COMMITTEE OF THE WHOLE NOVEMBER 19, 2001

**SITE DEVELOPMENT APPLICATION
1304231 ONTARIO LIMITED
FILE: DA.01.052**

**ATTACHMENT '2'
SITE PLAN**

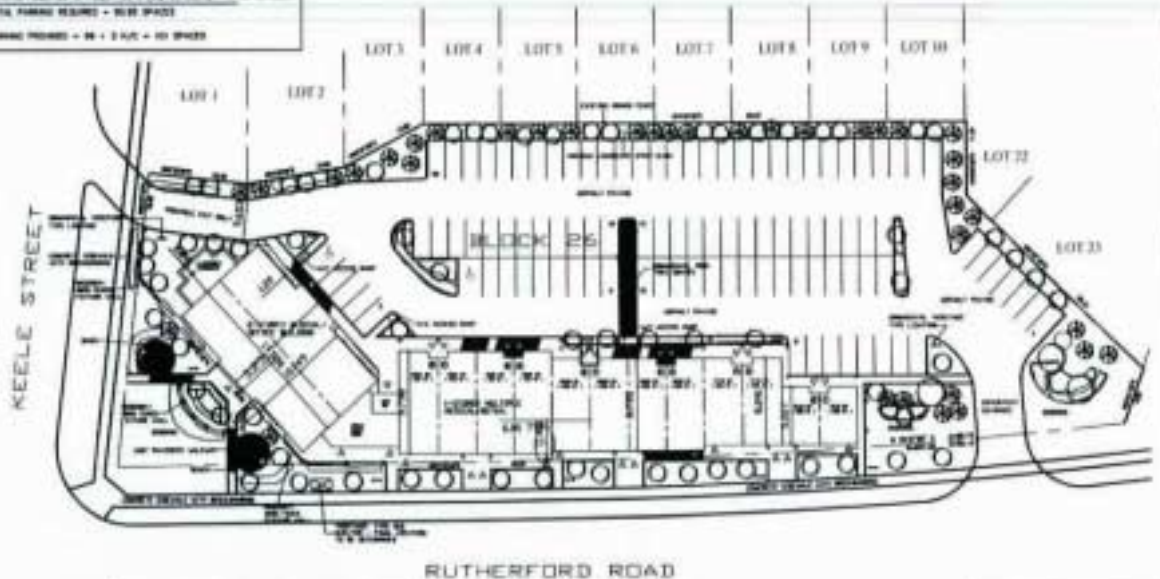
The site plan consists of a two-storey building located at the corner of Keele Street and Rutherford Road, with a one-storey wing extending east along Rutherford Road. The majority of the parking is located between the proposed building and the rear lot line. A full-movement access to the site is provided from Rutherford Road and a proposed one-way driveway provides egress to Keele Street.

A sidewalk is proposed both along the Keele Street and Rutherford Road frontages, with appropriate pedestrian connections into the site, and continues around the perimeter of the building into the central portion of the parking area. Sitting areas, including, a bench and landscaping are proposed in front of the main entrance to the building.

The Urban Design Department provided certain comments for the original design that remain applicable. Specifically, the planting in the 2.4m buffer area along the north lot line must be upgraded to provide an adequate vegetative buffer between the residential and commercial uses. Also, a sidewalk should be included along the north side of the two-storey building, connecting to Keele Street. An enclosed garbage is situated at the rear of the building, where the building changes from two storeys to a single storey, which is acceptable to staff.

- i) the final site plan, elevations, and landscape plan, including a landscape buffer along the north lot line, shall be approved by the Community Planning and Urban Design Departments;
- ii) the final site servicing and grading plans shall approved by the Engineering Department;
- iii) the Applicant shall satisfy all requirements of the Region of York;
- iv) the required variances (Committee of Adjustment File A295/01) shall be final and binding prior to the execution of the site plan agreement; and,
- v) the Owner shall pay to Vaughan by way of certified cheque, cash-in-lieu of dedication of parkland equivalent to 2% of the value of the lands, prior to the issuance of a building permit, in accordance with the Planning Act.

ATTACHMENT '3' SITE ELEVATIONS	FILE #	REPORT #	DATE: 01/10/26
	DR.01.002	LOCATION: PART 1/1" 16, CONC. 3	SCALE: NOT TO SCALE
	CITY OF VIRGINIA PLANNING DEPARTMENT	APPLICANT: 1304231 ONWARD LTD.

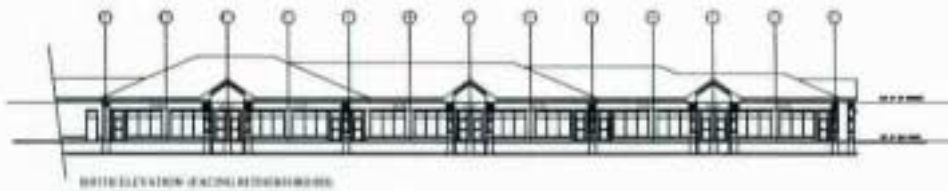
The proposed elevations have a residential character to them, being a maximum of two stories in height and utilizing brick and cedar-look shingles as the dominant finishing materials. The north end of the two-storey building is terraced downward to one-storey where the building is closest to the residential uses.

Precast concrete surrounds at each entrance accent the brick used on the building. A sign band is proposed along the front and back of the one storey building, using one consistent design. The hipped roof with gable ends provides some articulation and visual relief to its appearance. The roof for the one-storey building is also designed with a covered portico along the north face of the building, thereby protecting pedestrians from the environment. Brick piers are proposed along both facades of the one-storey building, which incorporate soldier courses, precast bands and antique lighting fixtures as accent design details.

The two-storey building at the corner provides a strong presence at the intersection, which is a gateway to the Maple Community. The materials used and the architectural details will be complementary to the adjacent residential development and will provide an attractive streetscape. Staff are satisfied with the proposed elevations.
